Connection differences for Mad City Piezo to Adept Piezo upgrades

When upgrading from a Mad City Piezo control box to an ASI Adept Piezo control box there are several differences to note regarding connections.

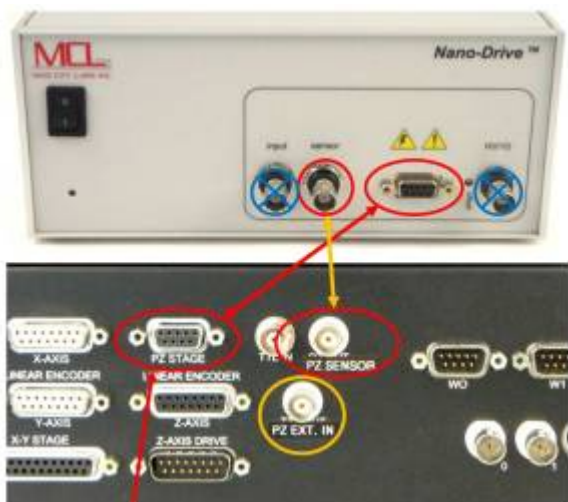
The DB-9 Male cable from the Piezo Z part of the stage connected to the MCL Nano-Drive at the DB-9 Female will now connect to the ASI Adept Piezo control box at the DB-9 Female labeled "PZ STAGE".

The "Input" on the Mad City Piezo control box is now internalized and is not on the ASI Adept Piezo control box.

The "Sensor" on the Mad City Piezo control box is now connected to the "PZ SENSOR" on the ASI Adept Piezo control box.

The "HV/10", (or High Voltage divided by ten Sensor), on the Mad City Piezo control box is now internalized on the ASI Adept Piezo control box.

And lastly the ASI Adept Piezo control box has an additional "PZ EXT.IN" input to accept a 0-10 VDC control voltage to move the Piezo that the Mad City Piezo control box does not have, see pictures 1 and 2.
